Three Mile Island Nuclear Station, Unit 2 (TMI-2)
NRC Possession Only License No. DPR 73
NRC Docket No. 50-320

Subject: License Amendment Request – Three Mile Island, Unit 2, Decommissioning
Technical Specifications, Response to Request for Additional Information

**THREE MILE ISLAND, UNIT No. 2 – REQUEST FOR ADDITIONAL INFORMATION FOR
REQUESTED LICENSING ACTION REGARDING DECOMMISSIONING TECHNICAL
SPECIFICATIONS EPID: L-2021-LLA-0038**

TMI-2 NMCA Process

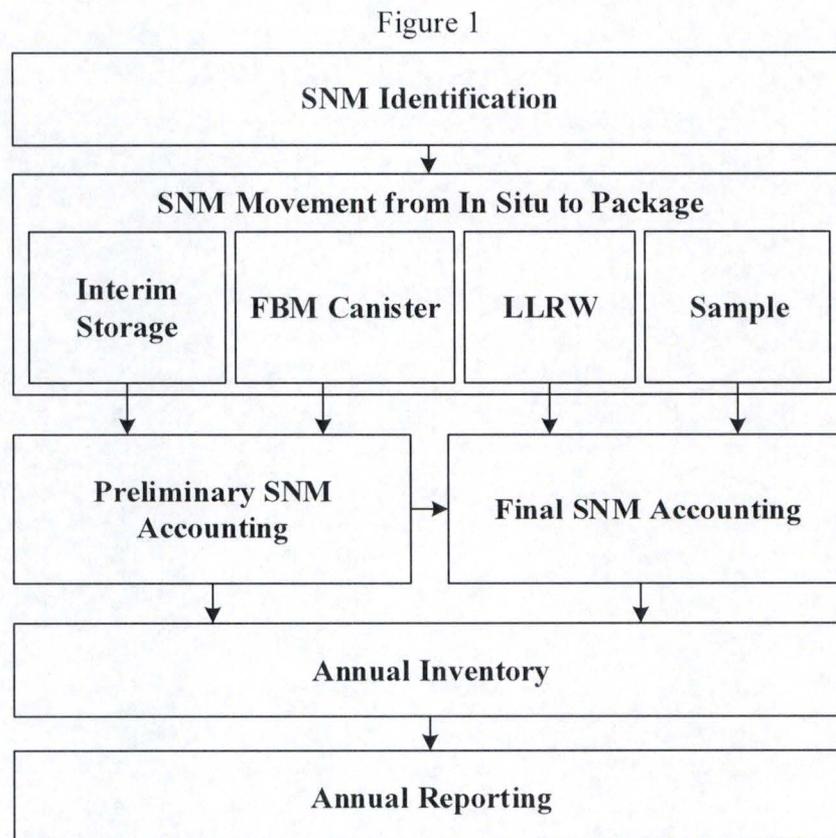
Path Forward: Describe how TMI-2 Solutions will control and account for Debris Material being removed from the Reactor Building to the Three Mile Island ISFSI throughout the decommissioning process in order to meet the applicable requirements of 10 CFR Part 74. Describe TMI-2 plans to refine current rough estimates of radionuclide content in Debris Material in existing reports and provide more accurate information on quantities of SNM as materials are packaged and removed.

Figure 1 provides a high-level flow chart for MC&A requirements from the existing configuration through the decommissioning project.
